MD330U(I) Release note

Product : MD330U/MD330UI

Model Name Report : AVer MD330U , AVer MD330UI

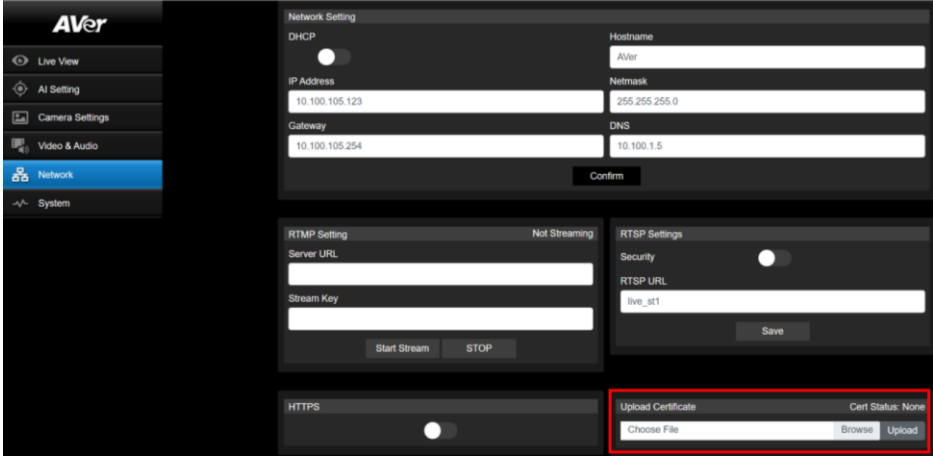
FW version	1.1.1049.0																			
Release date	2024/10/14																			
Checksum	1884d2ed070d35c8dedfc7fee8479790																			
New feature	<p>11. Support Zoom Mode</p> <p>If you are a Zoom Room user, please switch the mode of MD330U(I) to [Zoom Mode] Please note that MD330U(I) will automatically reboot after this action.</p> <p>How to change Mode</p> <table border="1"> <tr> <td>OSD</td> <td>[System]>>[ThemeMode]>> [AVer] or [Zoom]</td> </tr> <tr> <td>WEB UI</td> <td>[System]>>[ThemeMode]>> [AVer] or [Zoom]</td> </tr> </table> <p>**also support CGI/UVC-EXT , please contact tech support</p> <p>Behavior when mode change</p> <table border="1"> <thead> <tr> <th>Mode</th> <th>User Behavior</th> <th>Camera Behavior</th> </tr> </thead> <tbody> <tr> <td>AVer Mode</td> <td>Change to Zoom Mode</td> <td> <ul style="list-style-type: none"> Reboot and become Zoom Mode IR Night Vision = [Auto] Sensitivity=[High] </td> </tr> <tr> <td>Zoom Mode</td> <td>Load default</td> <td> <ul style="list-style-type: none"> Load Zoom Mode default setting *overwrite current user setting </td> </tr> </tbody> </table> <table border="1"> <thead> <tr> <th>Mode</th> <th>User Behavior</th> <th>Camera Behavior</th> </tr> </thead> <tbody> <tr> <td>Zoom Mode</td> <td>Change to AVer Mode</td> <td> <ul style="list-style-type: none"> Reboot and become AVer Mode Keep current user setting </td> </tr> </tbody> </table>	OSD	[System]>>[ThemeMode]>> [AVer] or [Zoom]	WEB UI	[System]>>[ThemeMode]>> [AVer] or [Zoom]	Mode	User Behavior	Camera Behavior	AVer Mode	Change to Zoom Mode	<ul style="list-style-type: none"> Reboot and become Zoom Mode IR Night Vision = [Auto] Sensitivity=[High] 	Zoom Mode	Load default	<ul style="list-style-type: none"> Load Zoom Mode default setting *overwrite current user setting 	Mode	User Behavior	Camera Behavior	Zoom Mode	Change to AVer Mode	<ul style="list-style-type: none"> Reboot and become AVer Mode Keep current user setting

OSD	[System]>>[ThemeMode]>> [AVer] or [Zoom]																			
WEB UI	[System]>>[ThemeMode]>> [AVer] or [Zoom]																			
Mode	User Behavior	Camera Behavior																		
AVer Mode	Change to Zoom Mode	<ul style="list-style-type: none"> Reboot and become Zoom Mode IR Night Vision = [Auto] Sensitivity=[High] 																		
Zoom Mode	Load default	<ul style="list-style-type: none"> Load Zoom Mode default setting *overwrite current user setting 																		
Mode	User Behavior	Camera Behavior																		
Zoom Mode	Change to AVer Mode	<ul style="list-style-type: none"> Reboot and become AVer Mode Keep current user setting

AVer Mode	Load default	<ul style="list-style-type: none"> ● Load AVer Mode default setting *overwrite current setting
Improvement	N/A

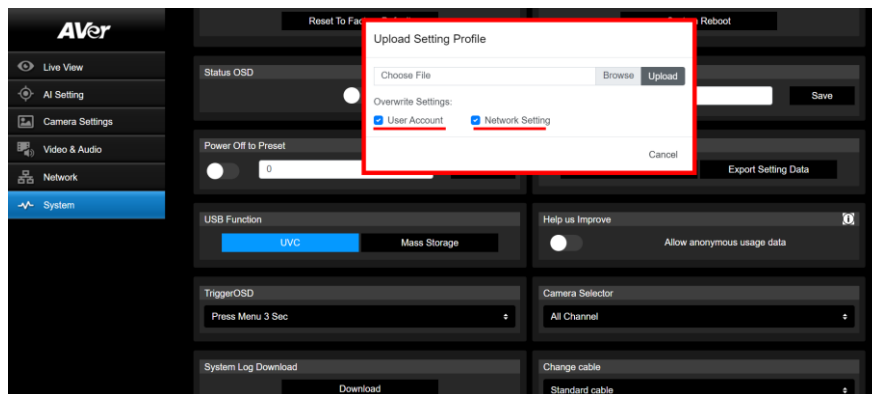
3. **Support PELCO-D & PELCO-P Camera Control Protocol (RS-232)**
4. **Now you can set the camera RC channel on WEB UI**

WebUI >> System >> Camera Selector

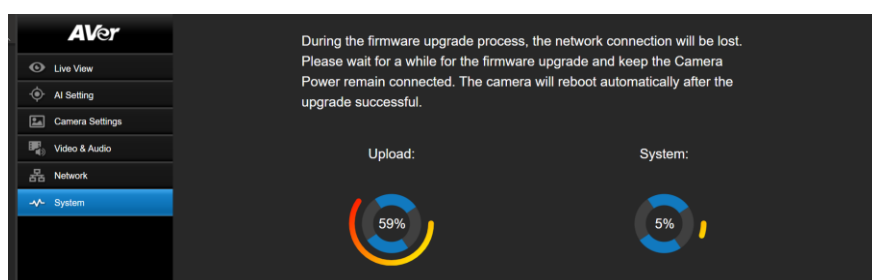
5. **Support more options to overwrite the setting when Importing Setting Data**

WebUI >> System >> Setting >> Import Setting Data

Check the [User Account] , [Network Setting] if you want to overwrite

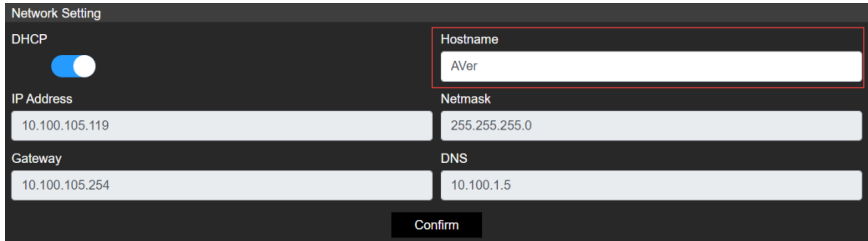
1. **Improve auto focus in handheld mode**
Now, slight hand shaking will not trigger refocusing, which greatly reduce the AF hunting.
2. **Optimize the firmware update UI**
You can now clearly see the current progress of the update.

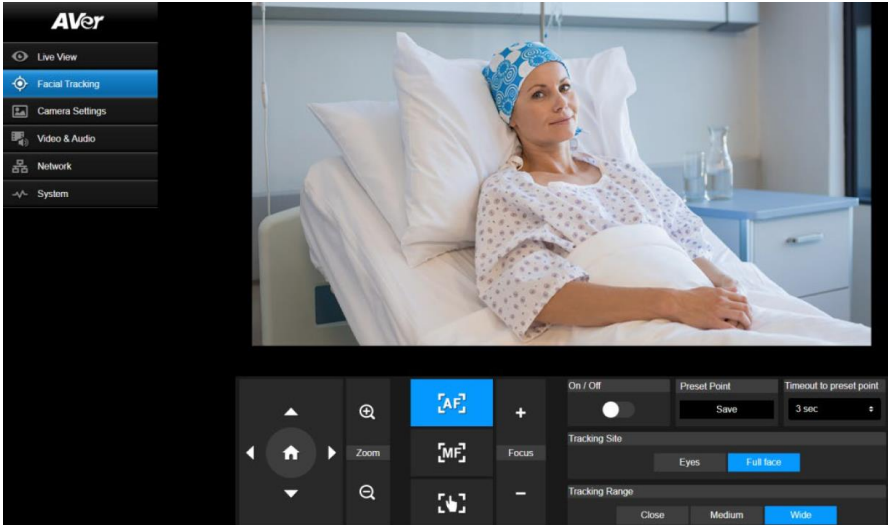
3. Optimize user flow when download log

A prompt window will pop up when the UI is temporarily frozen due to downloading logs.

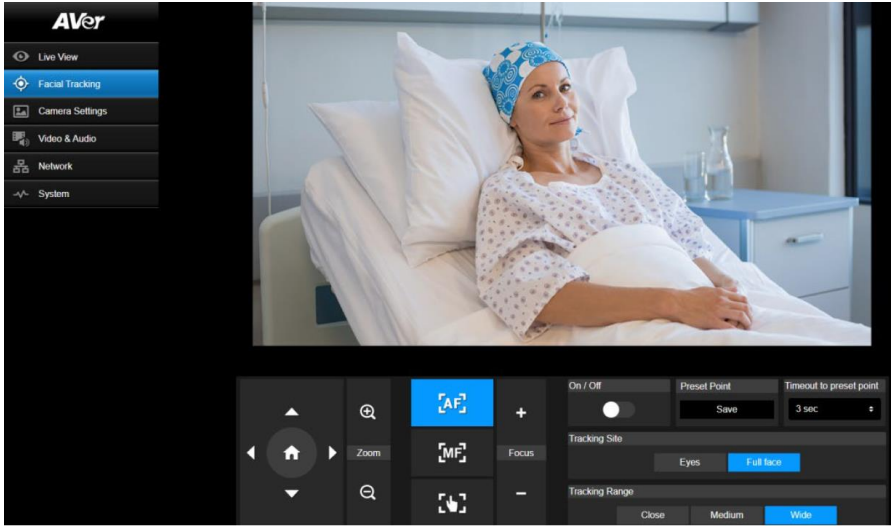
2. Beep when snapshot is successful

would trigger a beep on device speaker when the snapshot is successful
